Staff Report

To: Salt Lake City Planning Commission
From: Sara Javoronok, AICP, sara.javoronok@slcgov.com, 801-535-7625
Date: January 24, 2024
Re: PLNPCM2023-00762 – Liberty Corner

Design Review

Chris Zarek of Cowboy Partners is requesting Design Review approval for Liberty Corner, a proposed multifamily residential building at approximately 1265 South 300 West. The site consists of six parcels totaling approximately 89,305 sq. ft./2.05 acres. The subject property is in the CG zoning district. The proposed building is 7 stories tall and includes 200 two- to four-bedroom units (with average rents at 60% area median income (AMI), serving families ranging from 30% to 80% AMI), 269 parking spaces, and a first-floor daycare. Design Review approval is requested for the following:

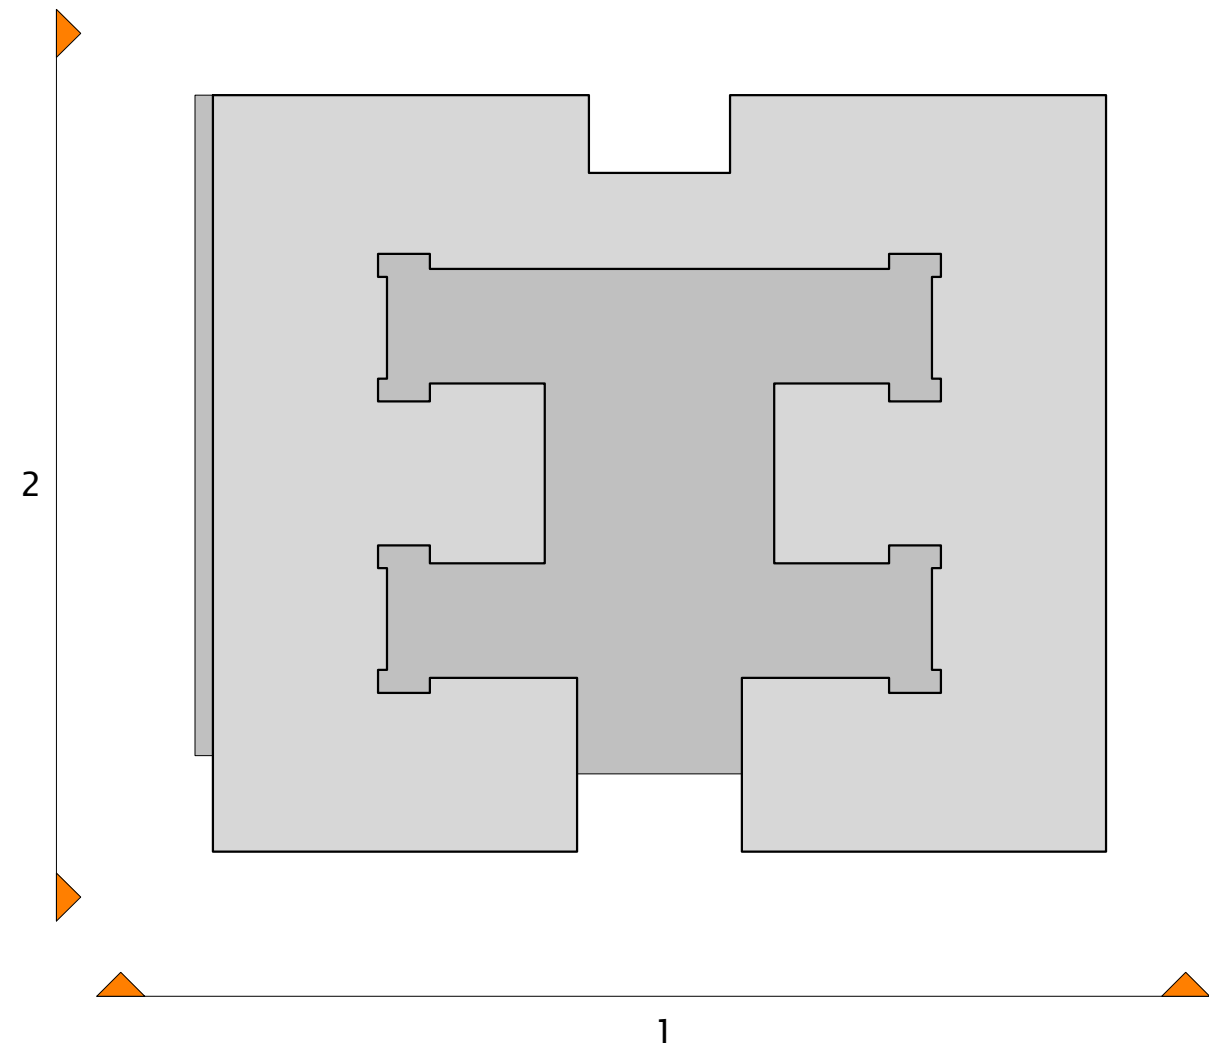
As identified earlier, the Downtown Building Heights text amendment included a maximum front yard setback of 10'. It also reduced the minimum front yard setback from 10' to 5'. The applicant is requesting a modification to increase the maximum front yard setback from 10' to 16' on 1300 South. The property line is angled from east to west and increases approximately 6'. The building will be aligned east-west and the front yard setback increases from just over 10' at the eastern boundary to approximately 16' on the western boundary.

1300 South elevation on right— shows proposed modification to increase the front yard setback to a maximum of 16' at the intersection with 300 West.

Staff supports this request as the existing sidewalk is 6' and there is not a park strip. The increased setback allows for additional separation between the building and the sidewalk. This is important given the high volume of both vehicular and pedestrian activity in this block of 1300 South. The yard will provide landscaping that meets the city's required 5' landscaping yard, a fenced amenity area for residents, and a larger paved area at the intersection of 1300 South and 300 West for people to walk and wait to cross the street.

BUILDING SECTION 2 1/16" = 1'-0"

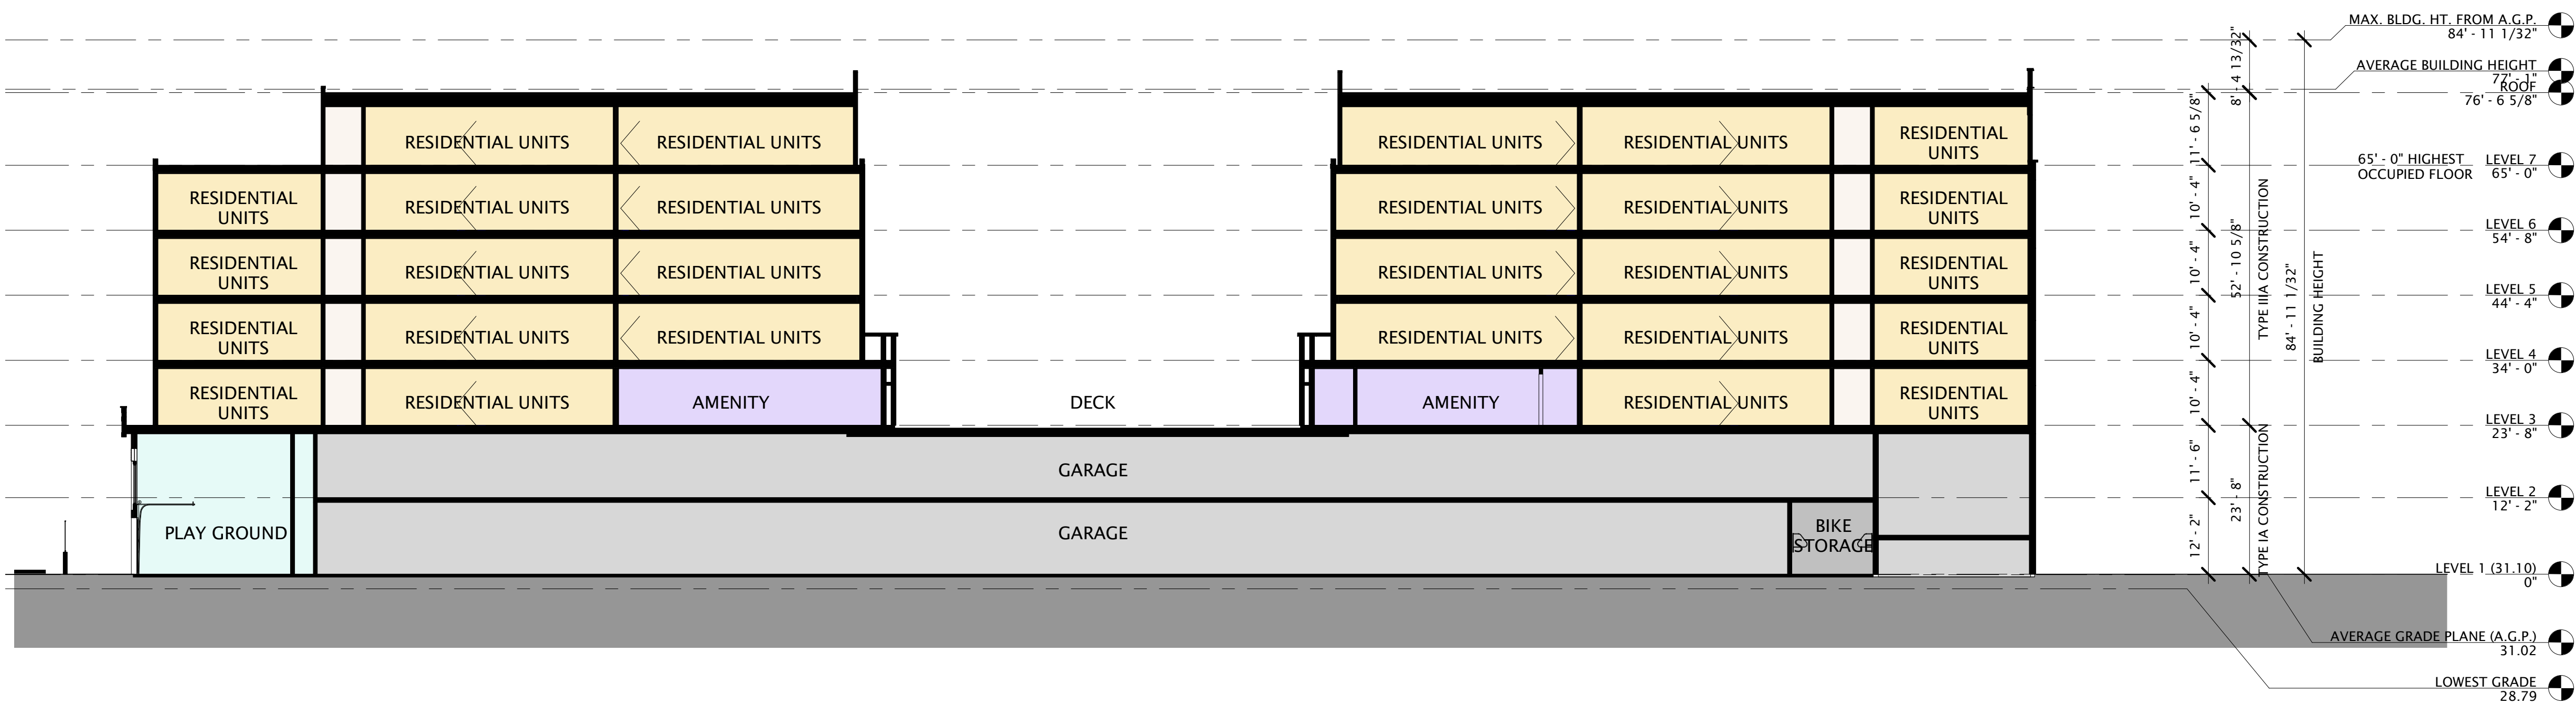
- Provide the finished grade for the entire site as well as the first floor elevation of all buildings. **Please see the elevations (Level 1, Average Grade Plane, Lowest Grade) on the section drawing of the updated design package.**
